PRS Hollowbody Electronics Diagram

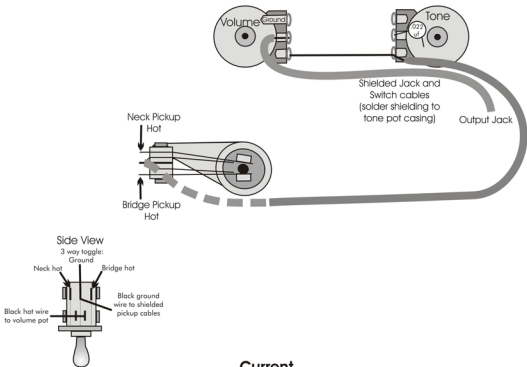
Pre-2007

Current

Note: Shielded Jack Cable is soldered to ground of 3-way toggle. Shielded cables of pickup harness wires are soldered to jack cable. Black ground wire is soldered to shielding of pickup harness. Solder bridge ground wire to any shielded cable of pickup harness.
